Docket Item # 5
BAR CASE # 2015-0246

ISSUE: Alterations

LOCATION: 515 North Washington Street
,

The applicant requests a Certificate of Appropriateness for approval of full frame replacement windows. The proposed windows will be double-glazed, simulated divided light painted wood windows with a 7/8" putty glazed muntin profile. The proposed windows will replace existing double-glazed windows dating to the 1980s. The request is for replacement windows on the two street-facing (west and north) elevations.

Mock-Up: New Insulated Double- Glazed Window

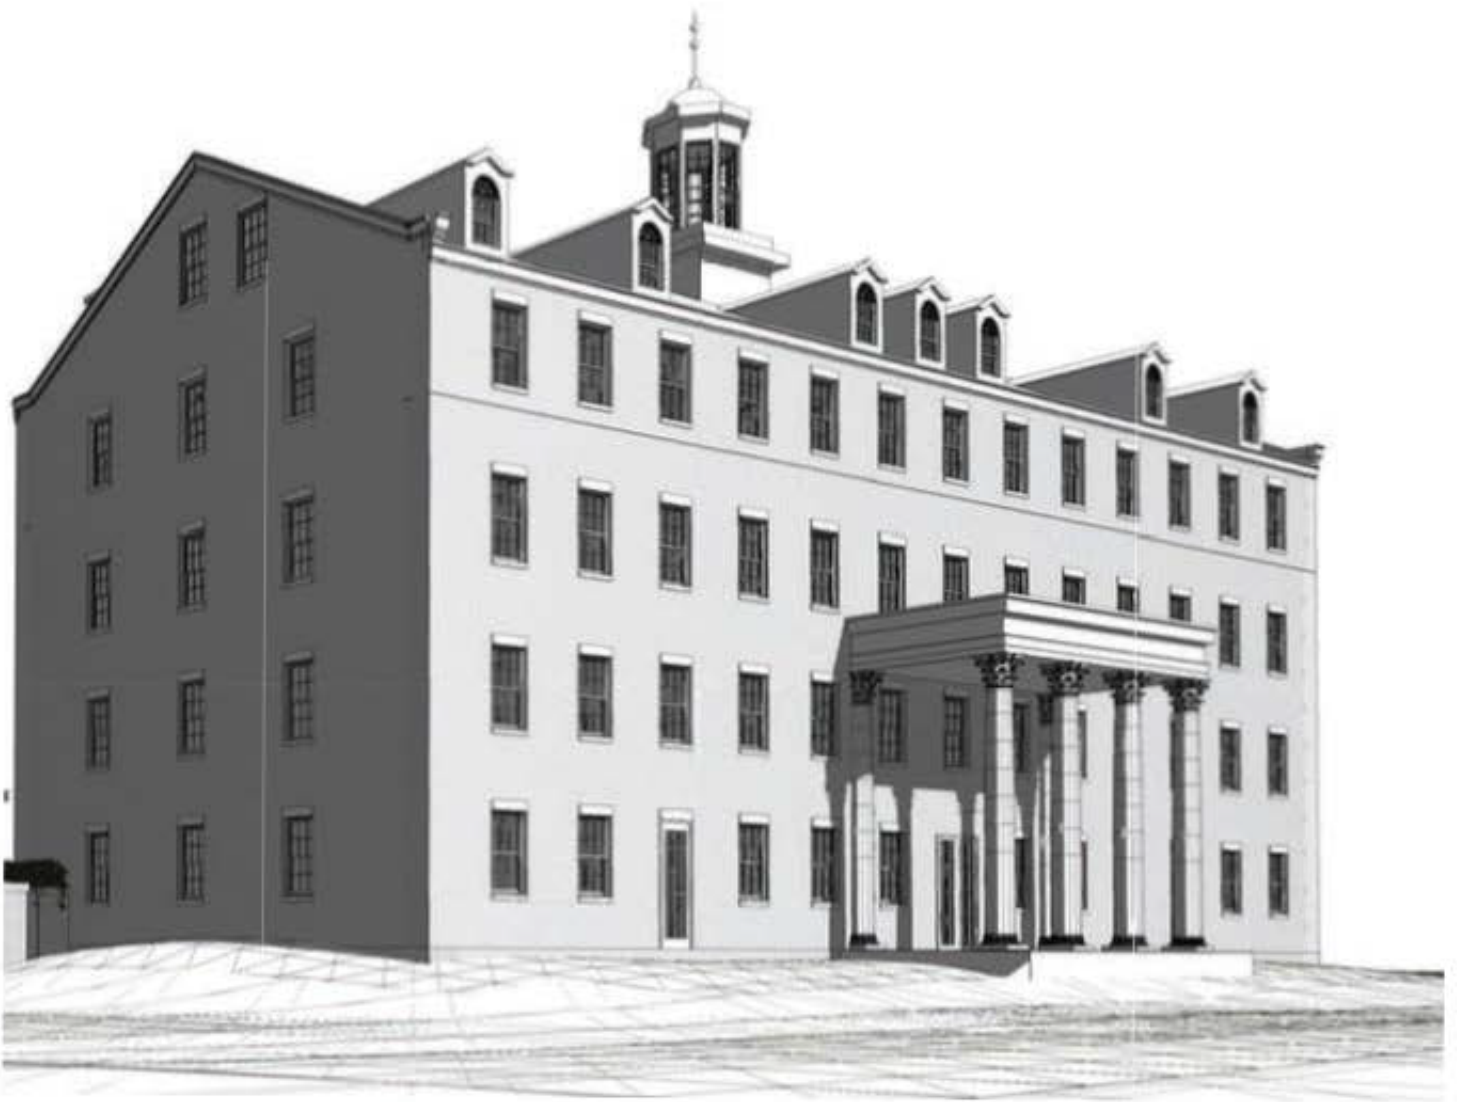
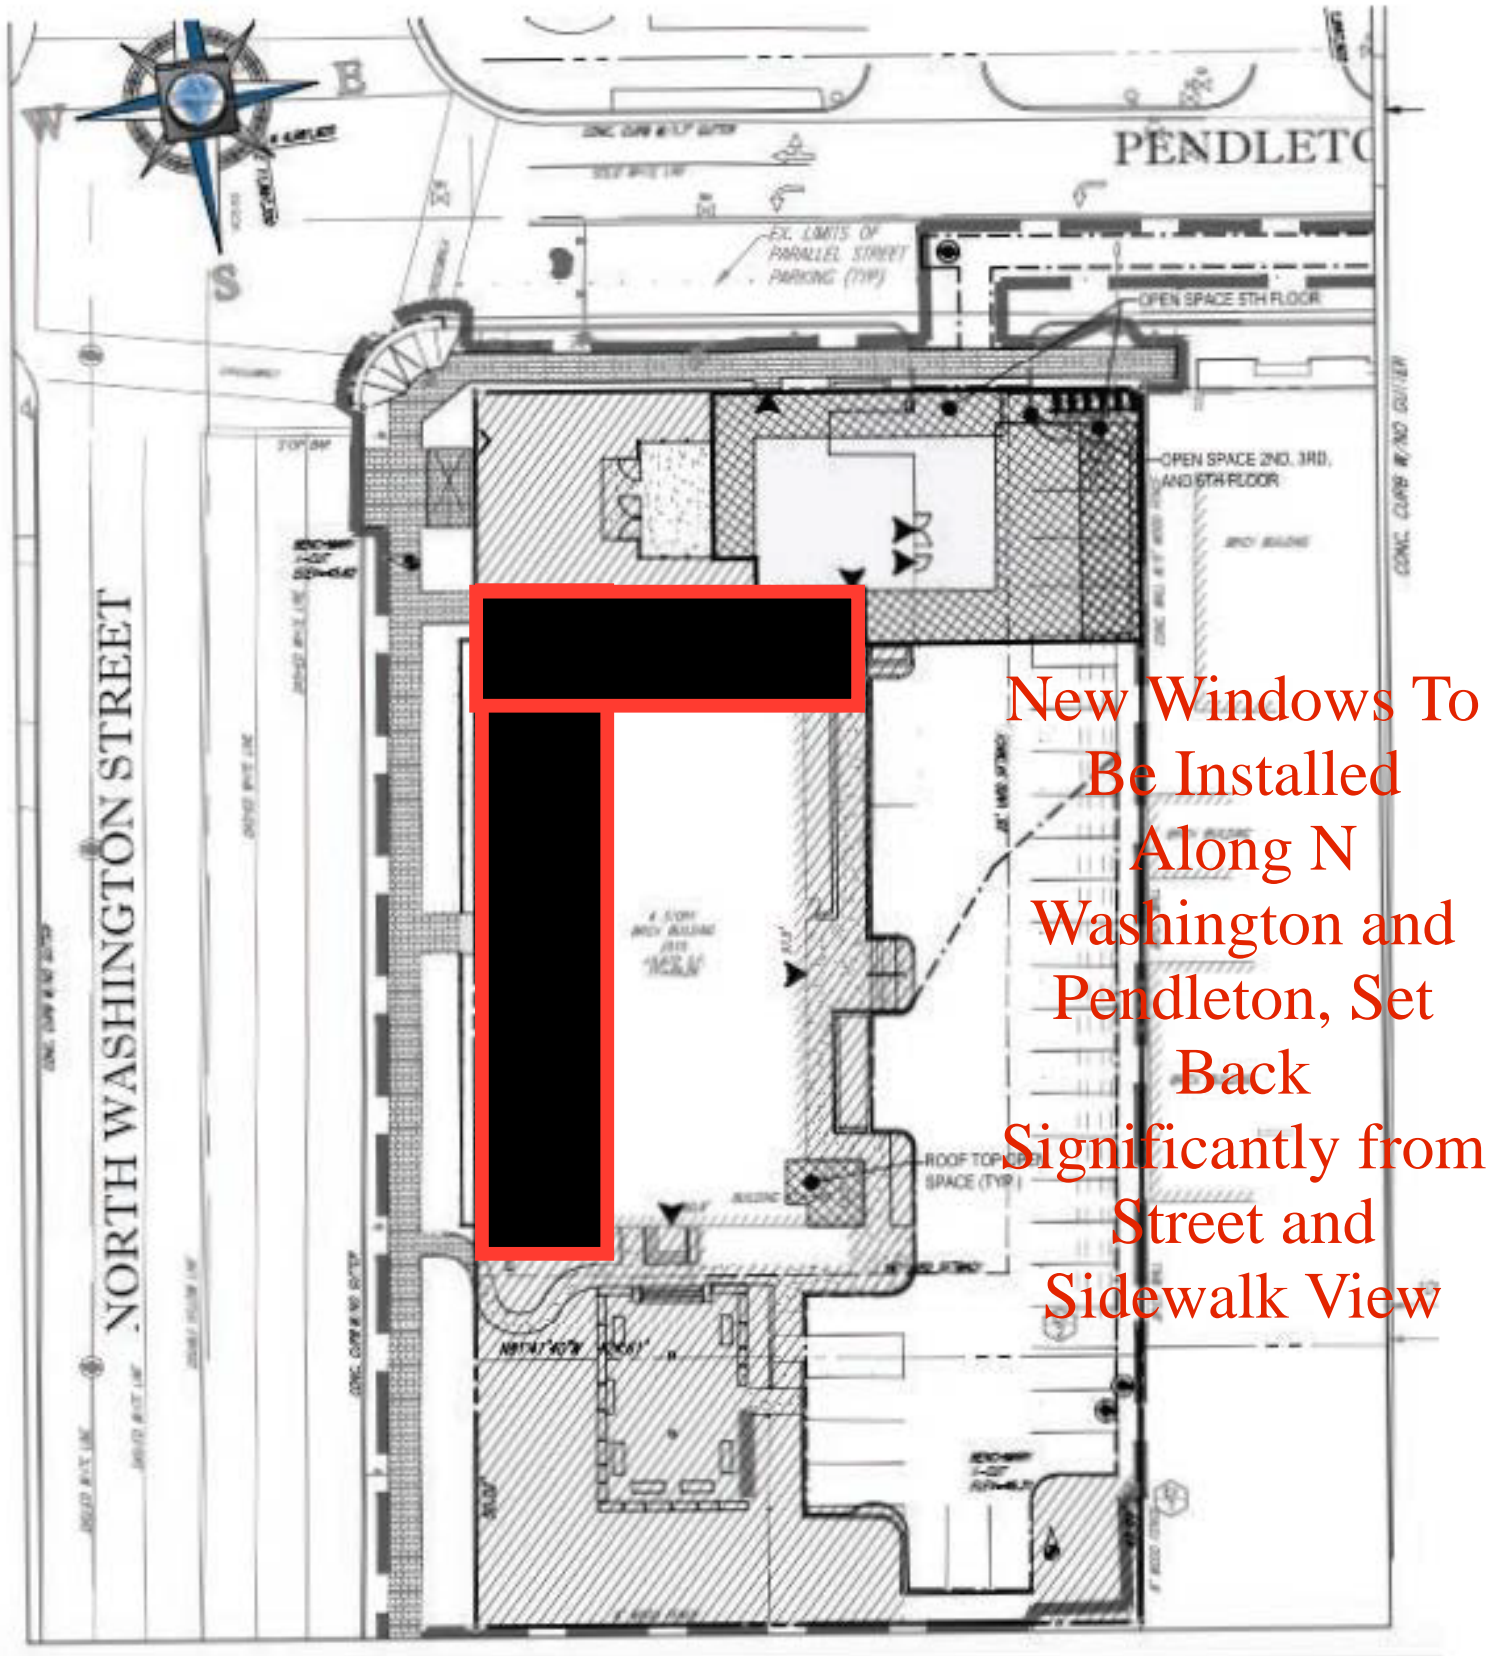
In this particular case, the windows are set back at least 15 feet from the sidewalk and the building is four stories in height. Due to the location of the windows, staff believes it will be visually indiscernible to the majority of public from the sidewalk whether or not the windows are single- or double-glazed. This has been confirmed in the field as the rear replacement windows have already been installed. Additionally, staff notes that this particular building was not a pristine mid-19th-century building when this project started. While it has retained a high level of historic integrity, the building has undergone numerous alterations over the years including the addition of the front portico, dormers on the front and rear, as well as replacement windows. Staff finds that the circumstances of the request allow the Board to support double-glazed windows here without setting a precedent for other 19th-century buildings.

Staff supports the request for double-glazed, simulated divided light wood windows on the two street-facing elevations.

Staff recommends approval of the application with the condition that replacement windows comply with the Alexandria Replacement Window Performance Specifications.
